# HUGHES SERVICE INFORMATION NOTICE

NOTICE NO. HN-144

**SUBJECT:** KIT INSTALLATION, PN 369D290140 - AUXILIARY FAIRINGS AND SEALS, ENGINE AIR FILTER (PARTICLE SEPARATOR)

**MODELS AFFECTED:** 500 Series Model 369H Helicopters equipped with PN 369H90148-Basic or -501 Particle Separator Kit

Figure 1. Installation of auxiliary fairings and seals,  
particle separator (Sheet 1 of 2)

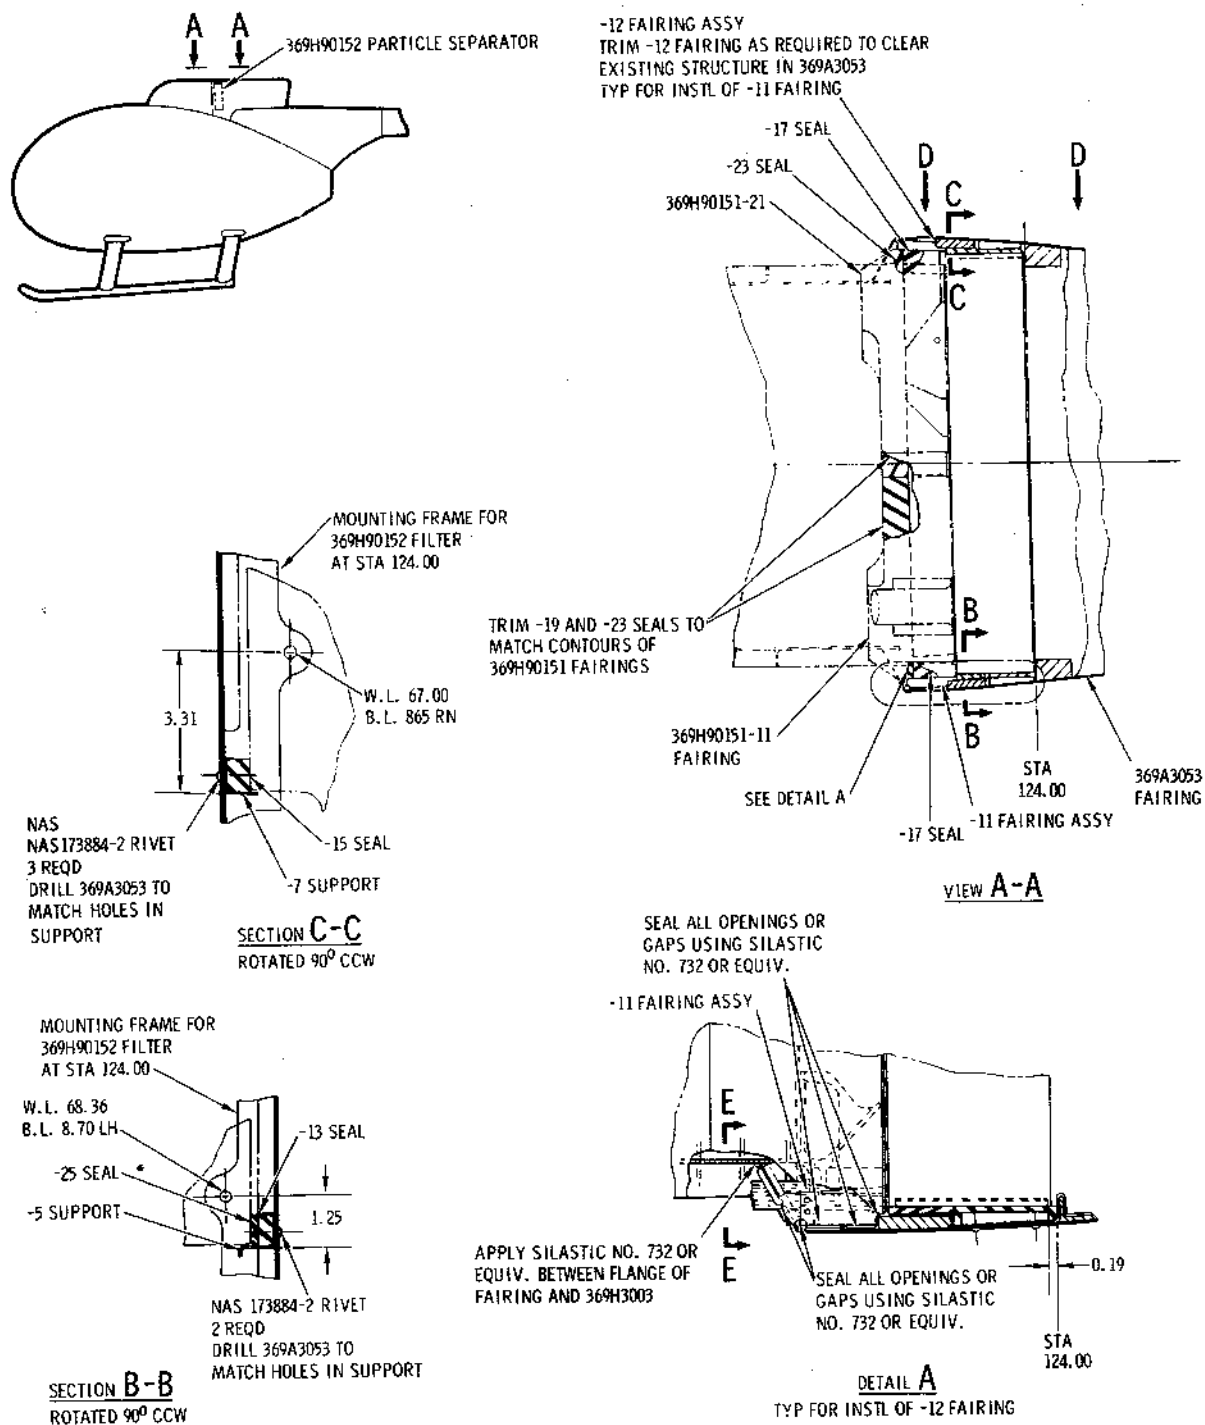
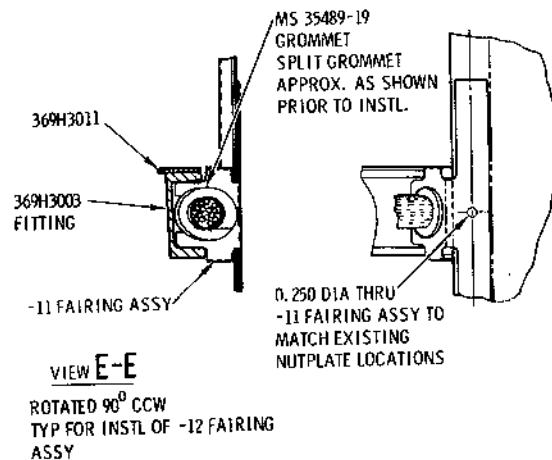
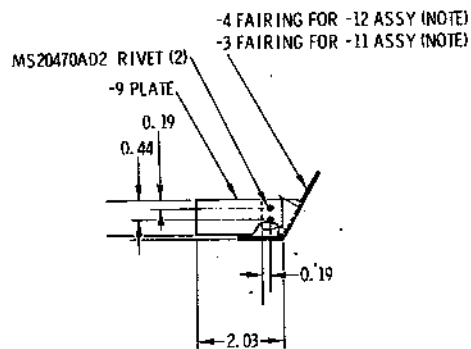
1. Position -5 support aft of filter mounting frame on LH aft engine air inlet fairing, per dimensions shown in Figure 1, Detail A and Section B-B. Install -5 support to fairing with two NAS1738B4-2 rivets. Apply -13 seal to support as shown in Detail A.

2. Apply -25 seal to aft inlet fairing, with -25 seal forward of and in line with -13 seal as shown in Detail A.
3. Position -11 fairing with flanges in mast support structure fitting and on forward side of mounting frame of aft inlet fairing. Mark and drill 0.250 inch diameter hole in -11 fairing to match existing nutplate location on aft engine air inlet fairing.

4. Split grommet and install grommet on wiring/controls bundle; insert grommet into -11 fairing as shown.
5. Temporarily install -11 fairing with grommet to aft engine air inlet fairing with existing hardware.

6. Install -17 seal on underside of 369H90151-11 fairing; locate -17 seal on aft outboard side of fairing as shown.
7. Install -19 seal on underside of 369H90151-11 fairing; locate -19 seal at forward edge of fairing as shown. Trim -19 seal at forward edge of fairing as shown. Trim -19 seal to match contour of fairing.

8. Seal gaps between flanges of -11 fairing and mast support structure fitting. Also seal all openings and gaps in areas shown in Detail A.

Figure 1. Installation of auxiliary fairings and seals,  
particle separator (Sheet 2 of 2)

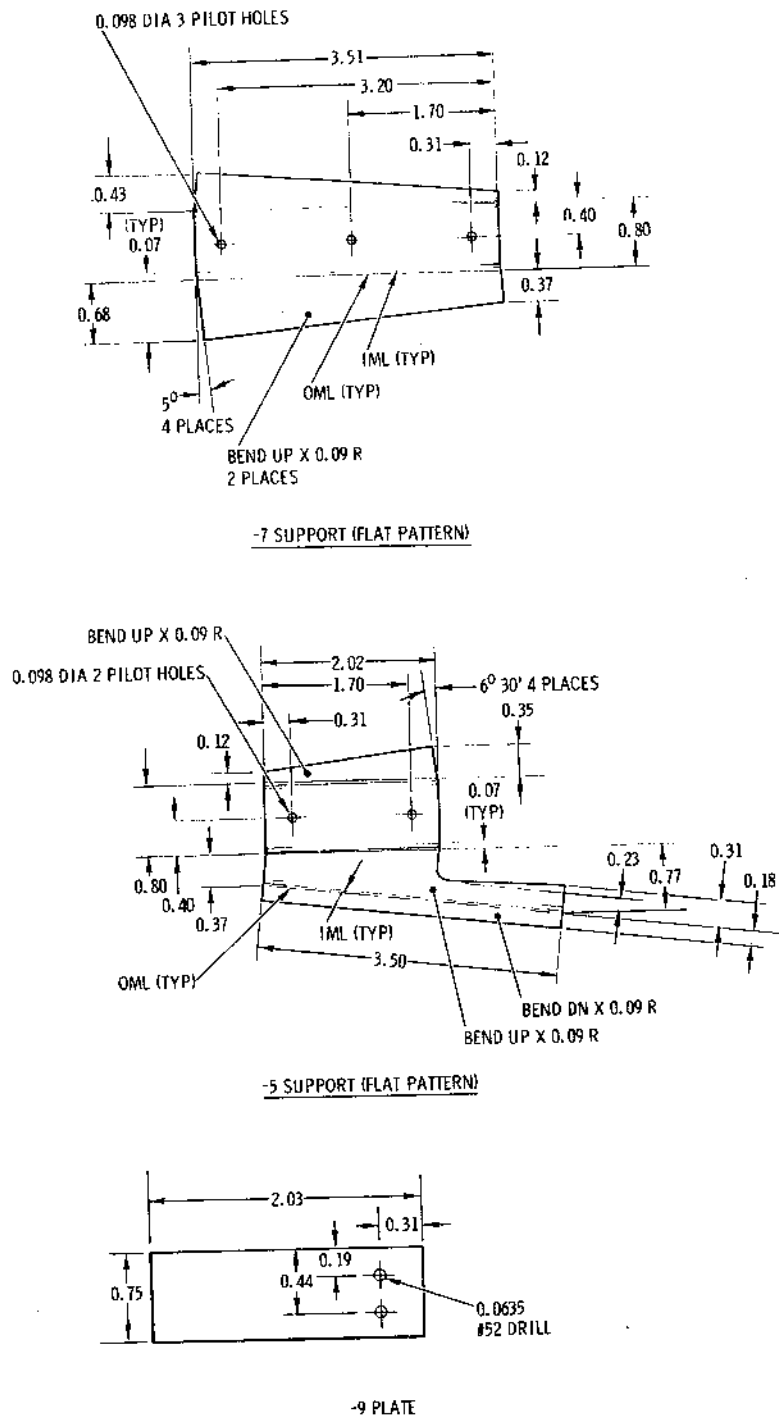
1. Position -7 support aft of filter mounting frame on RH aft engine air inlet fairing, per dimensions shown in Figure 1, View A-A and Section C-C. Install support to fairing with three NAS1738B4-2 rivets. Apply -15 seal to support as shown.

2. Position -12 fairing with flanges in mast support structure fitting on forward side of mounting frame of aft inlet fairing. Mark and drill 0.250 inch diameter hole in -11 fairing to match existing nutplate location on aft engine inlet fairing.

3. Split grommet and install grommet on wiring/controls bundle; insert grommet into -12 fairing as shown.
4. Temporarily install -12 fairing with grommet to aft engine inlet fairing with existing hardware.

5. Install -17 seal on underside of 369H90151-21 fairing; locate -17 seal on aft outboard side of fairing as shown.
6. Install -23 seal on underside of 369H90151-21 fairing; locate -23 seal at forward edge of fairing as shown. Trim -23 seal to match contour of fairing.

7. Seal gaps between flanges of -12 fairing and mast support structure fitting. Also seal all openings and gaps in areas shown in Detail A.

Figure 2. Field fabrication - auxiliary fairings and supports (Sheet 1 of 2)

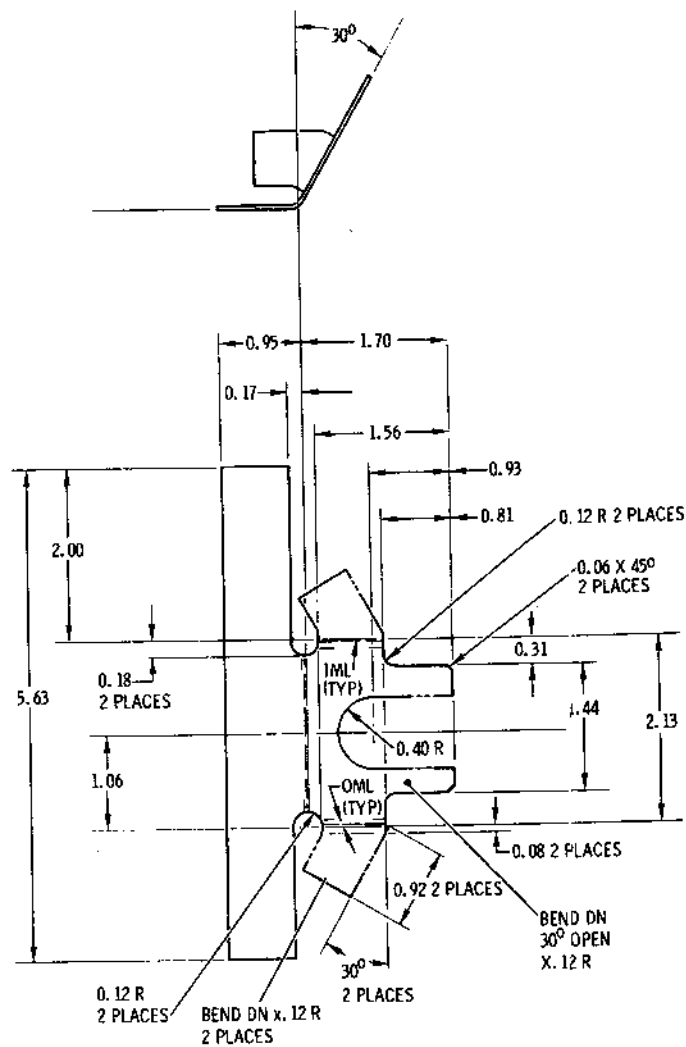
1. The 369D290140-5 and -7 supports, and -11 and -12 fairing assemblies may be field fabricated per dimensions shown in Figure 2. Apply coat of primer to parts.
2. Refer to Materials listing for dimensions for all seals (pressure sensitive tape).

Figure 3. Rework of pressure switch  
to 369A8402-7 configuration

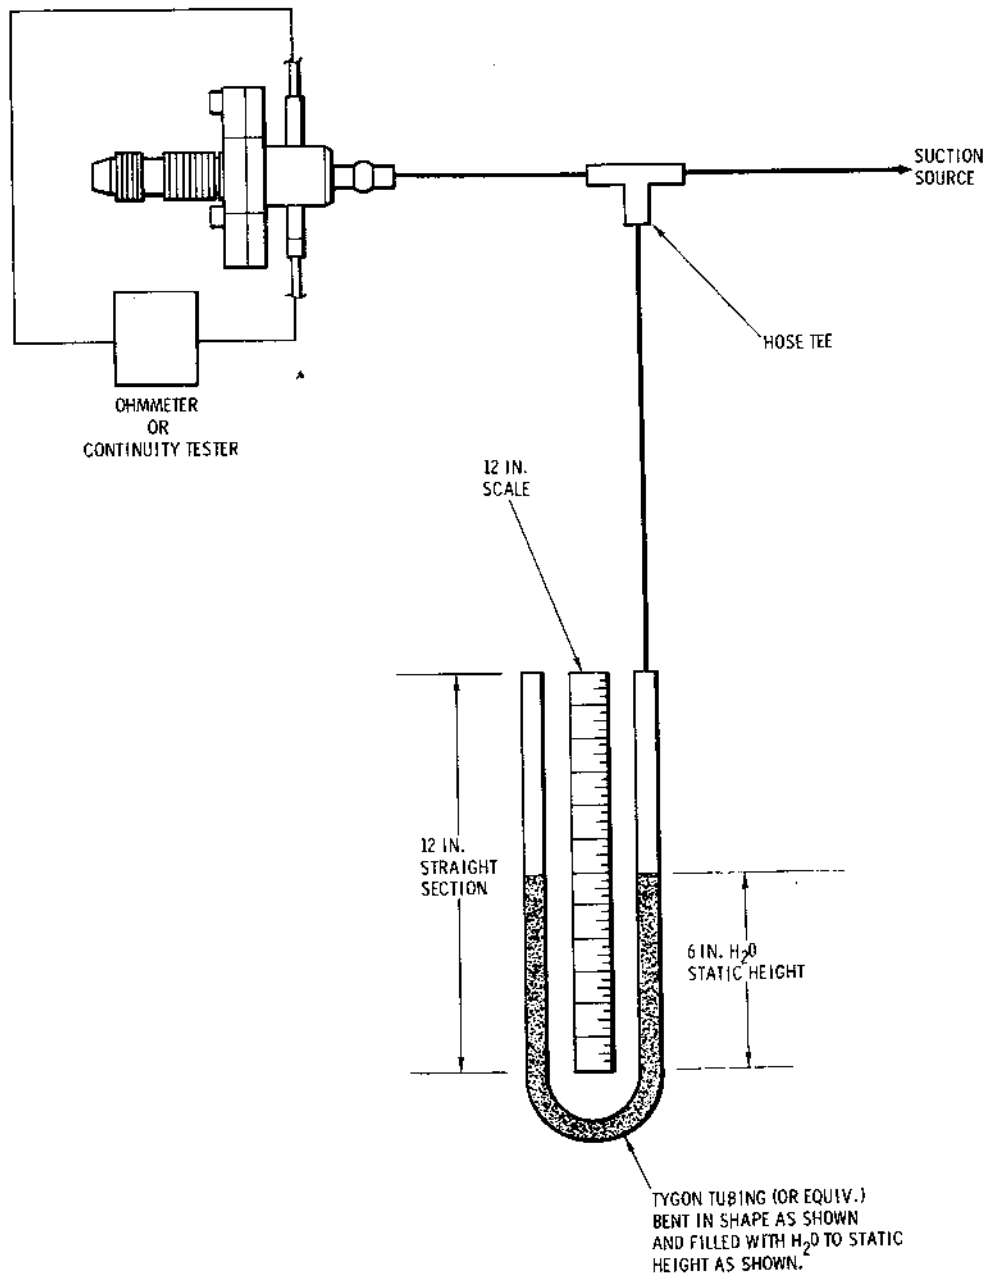
1. Disconnect and remove pressure switch from angle inside plenum chamber. (Refer to HMI Appendix A.)
2. Remove lockwire and three retaining screws; carefully separate switch body halves; remove switch diaphragm-magnet assembly and diaphragm return spring. (See Figure 3.)

3. Clean both body halves of any dust or debris.
4. Install new diaphragm-magnet assembly in cavity of switch body with threaded port. The diaphragm-magnet assembly should be placed in the cavity with magnet facing up as shown.

5. Install new diaphragm return spring on spring centering boss of diaphragm-magnet assembly.
6. Carefully lower remaining half of switch body onto the partial assembly; check that magnet and diaphragm return spring are centered in their proper bores.

7. Before bringing the two switch body halves completely together, carefully rotate either body half to align the three retaining screw holes. After proper alignment, check the diaphragm to ensure that it has remained centered in the body cavity, and that it has not folded or twisted.

8. Install the three retaining screws until snug and install lockwire.
9. Install new nameplate over existing nameplate on switch body.
